## SERVICE INSTRUCTION

# Information on fuse box assy. modifications for ROTAX® Engine Type 912 i (Series)

ATA System: 76-10-00 Fuse box

Fig. 1  
Fuse box regulator B

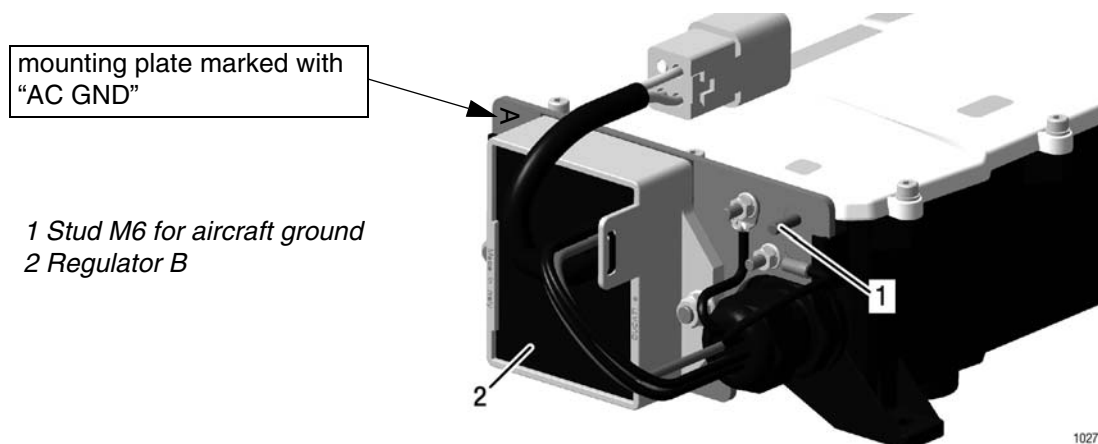
In the course of further development and standardization a new fuse box has been introduced. The new fuse box incorporates larger diameter grounding studs on the regulator B mounting plate (AC GND). Grounding studs have been increased in size from M4 x 1 to M6 x 1.

This increase does have an influence to the design of the aircraft wiring harness in case of replacement on ROTAX® 912 iS and ROTAX® 912 iS Sport engines equipped with the previous style of fuse box assy.

When retrofitting the new style fuse box assy. (part no. 881321) to an older engine, the connection to the aircraft harness must have its ground connectors replaced e.g. with larger M6 (1/4 inch) ring terminal and needs to be installed with e.g. washer and appropriate lock nut. See [Fig. 1](#).
